RENESAS TECHNICAL UPDATE

Product Category	MPU & MCU	Document No.	TN-16C-A235A/E	Rev.	1.00
Title	Errata to R32C/151 Group User's Manual: Hardware		Information Category	Technical Notification	
Applicable Product	R32C/151 Group	Lot No.	Reference Document	R32C/151 Group User's Manual: Hardware Rev. 1.10 (REJ09B0503-0110)

This document describes corrections to the R32C/151 Group User's Manual: Hardware, Rev. 1.10. The corrections are indicated in red in the list below.

Figure 7.1 Clock Generation Circuitry

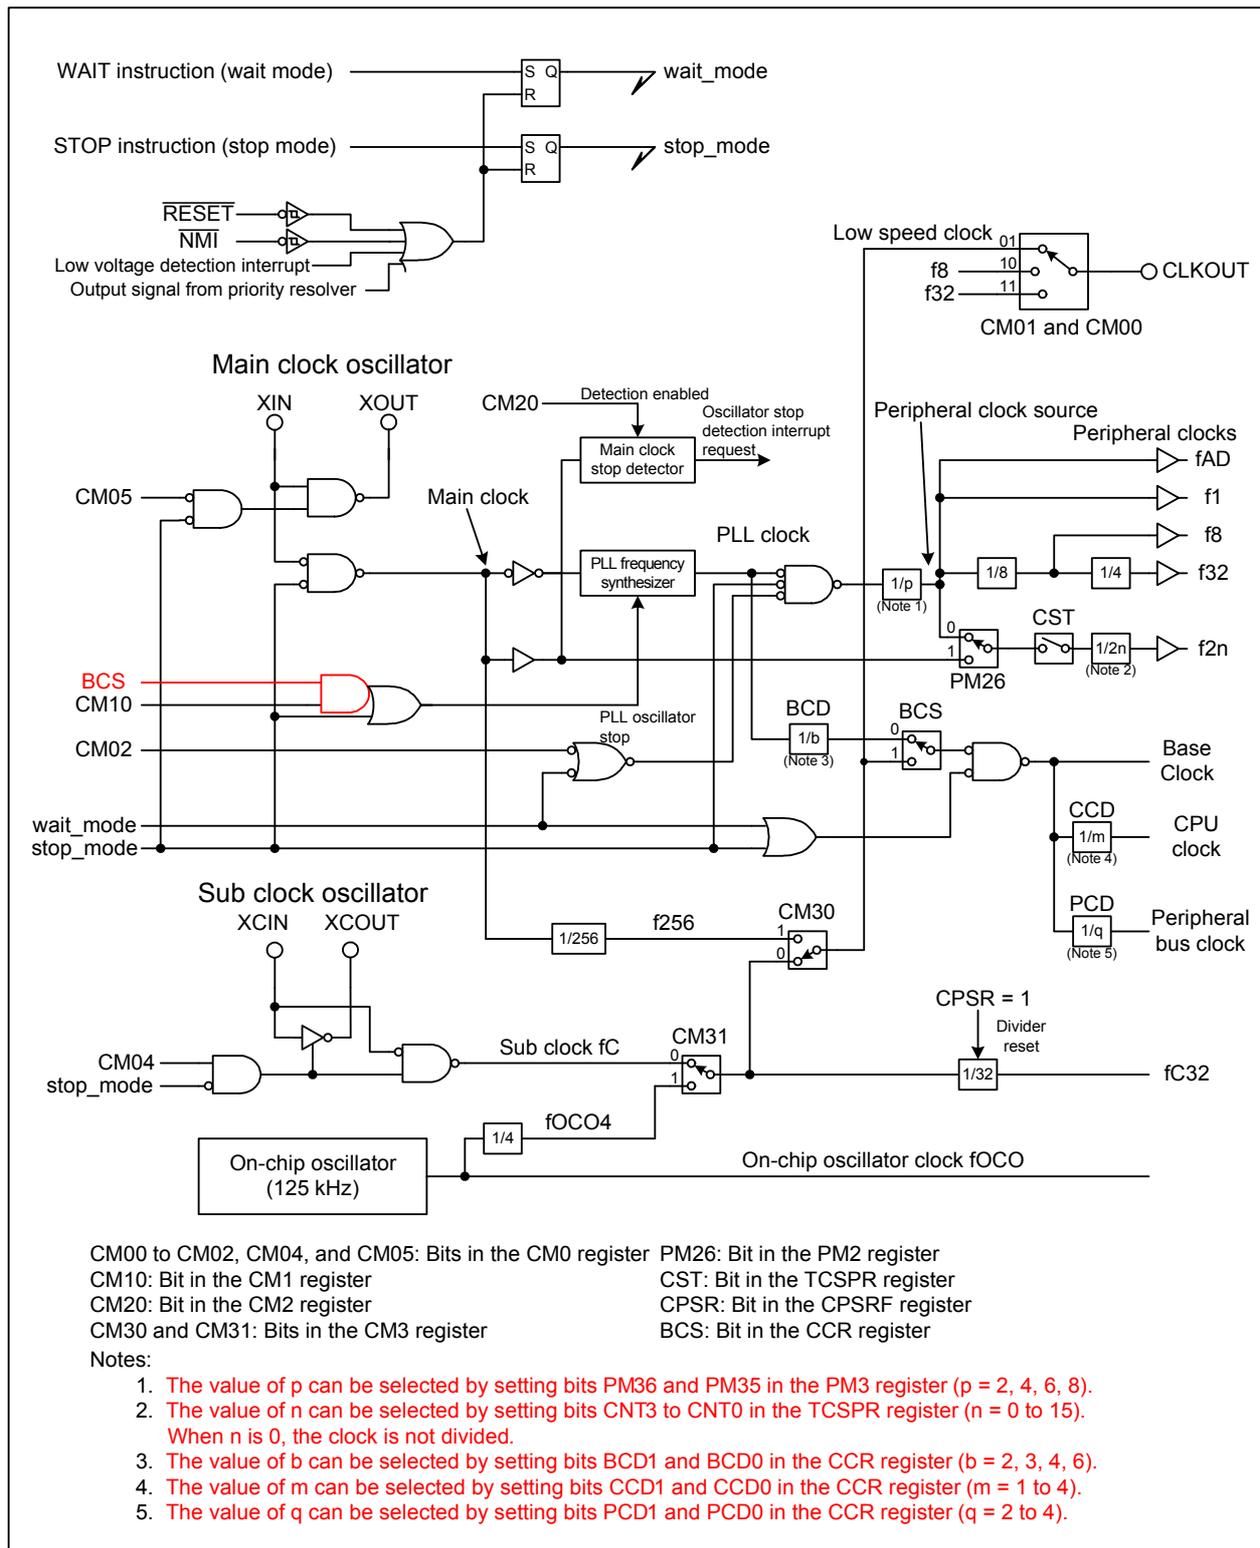
•Page 91 of 628, Figure 7.1 is corrected as follows:

Figure 20.1 CRC Calculator Block Diagram

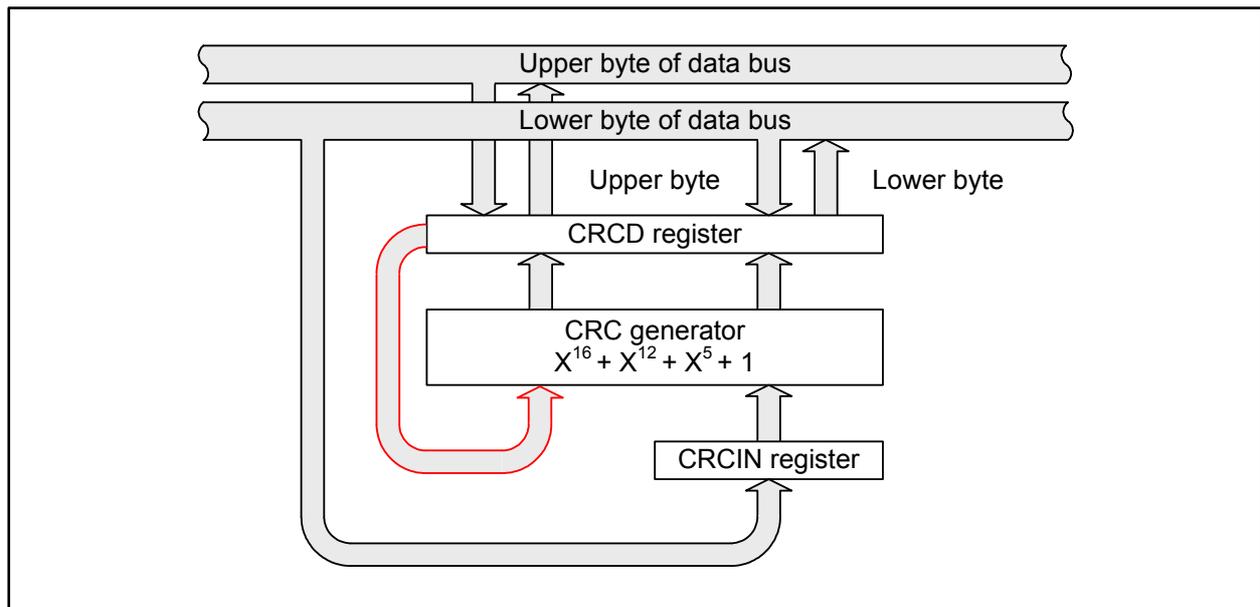
•Page 313 of 628, Figure 20.1 is corrected as follows:

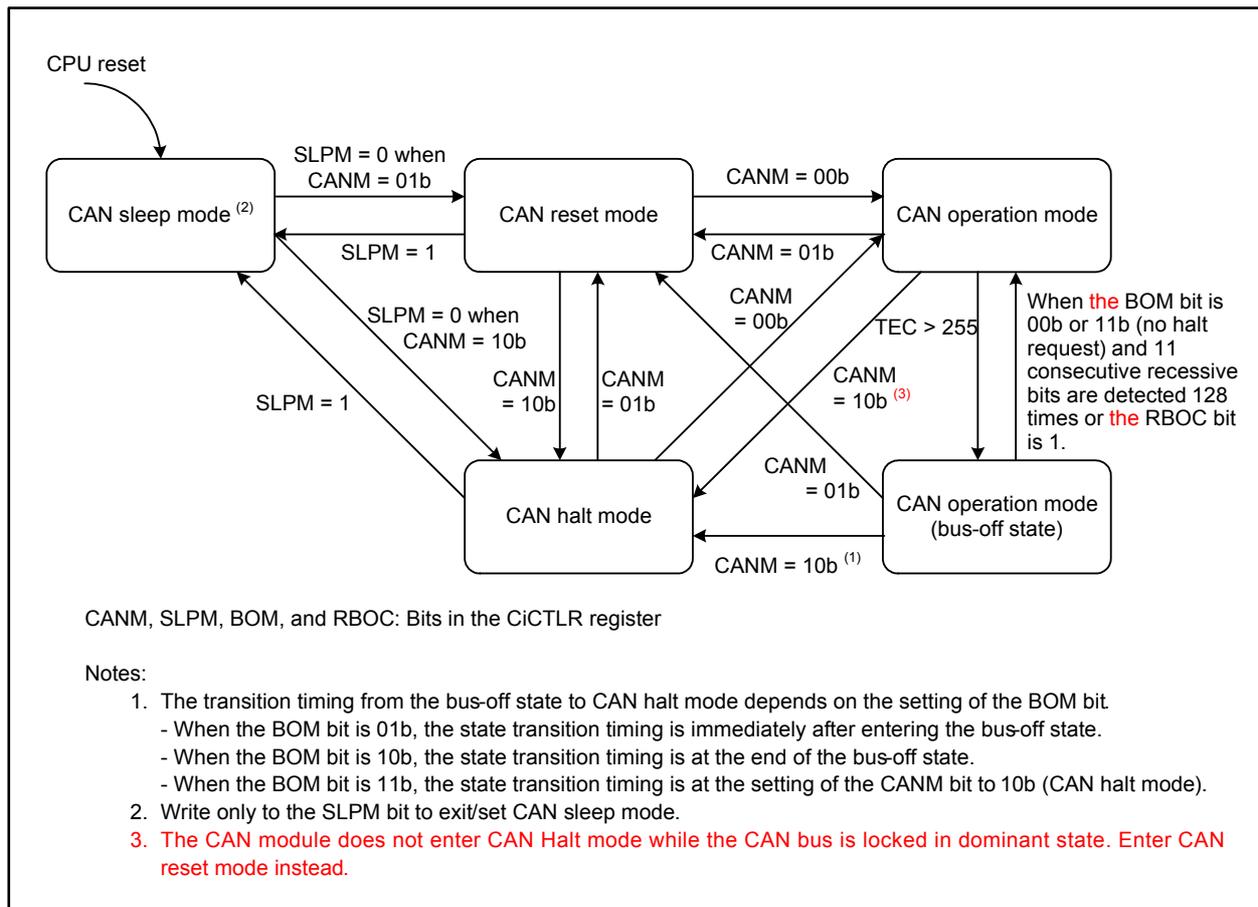
•Page 479 of 628, Note 3 is added to Figure 25.34 as follows (refer to TN-16C-A229A/E):

Figure 26.1 Typical I/O Pin Block Diagram (i = 0 to 15; j = 0 to 7)

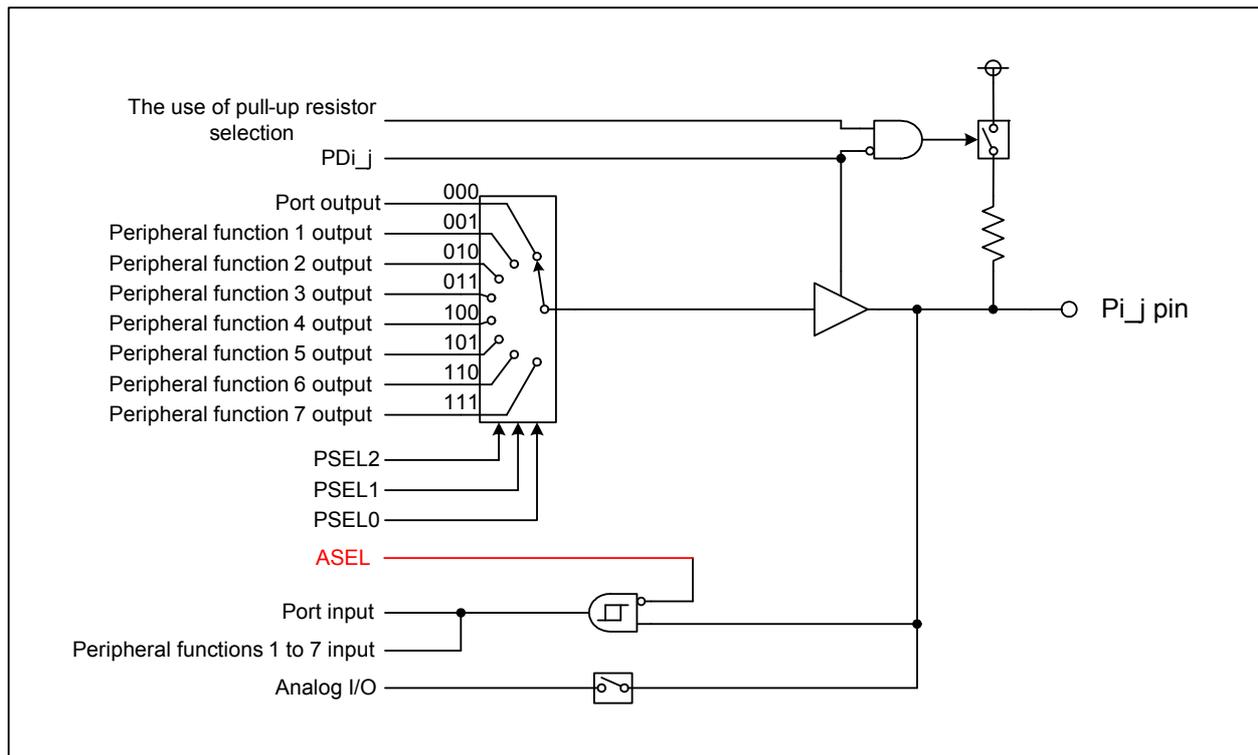
•Page 497 of 628, Figure 256.1 is corrected as follows (refer to TN-16C-A200A/E):
